Process/Product Change Notification

Ta Polymer SMD Black Epoxy Conversion

Date: 05082013	ID Number (DDMMYY): PCN05082013-CMC
Affected Products	KEMET Ta Surface Mount (SMD) Polymer Series, included in table 1, produced in Suzhou:
	Ta Polymer SMD Series
	T520 Polymer Tantalum
	T521 High Voltage Polymer Tantalum
	T522 Reduced Leakage Polymer Tantalum
	T525 125°C Rated Polymer Tantalum
	T528 Low ESL/Facedown Terminal Polymer Tantalum
	T530 High Capacitance/125°C Rated Polymer Tantalum
	Table 1. Affected Polymer SMD Series with Black Epoxy Conversion
Change	KEMET Suzhou Plant has evaluated and qualified the new black epoxy material setting and will start the conversion from yellow to black.
Justification and Benefits	KEMET Suzhou Plant has evaluated and qualified the new black epoxy material setting and will start the conversion from yellow to black. This conversion allows KEMET to be consistent and standardize with industry and minimize the future risk of potential raw material cost escalation/availability related to usage of yellow epoxy in specialized industries.

Color change and Date Code change (no impact in the part number)

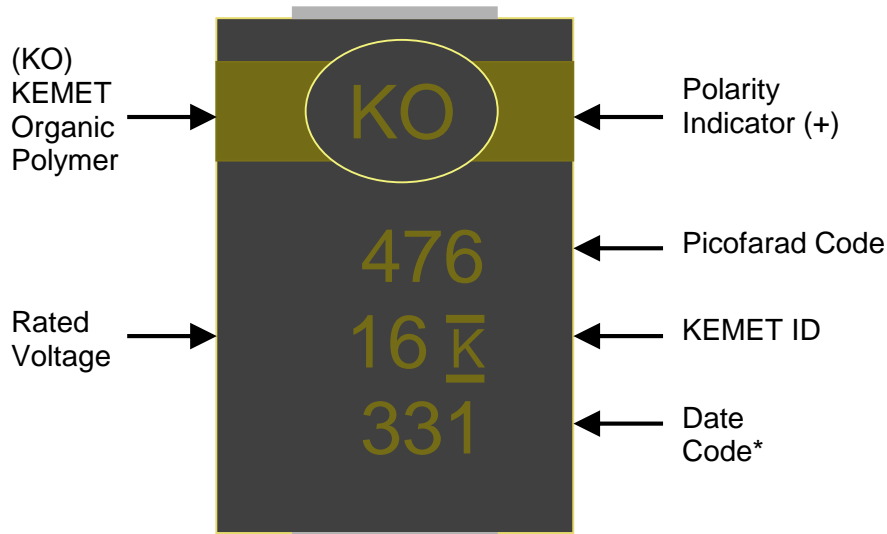
* 331 = 31th week of 2013

* 331 = 31th week of 2013
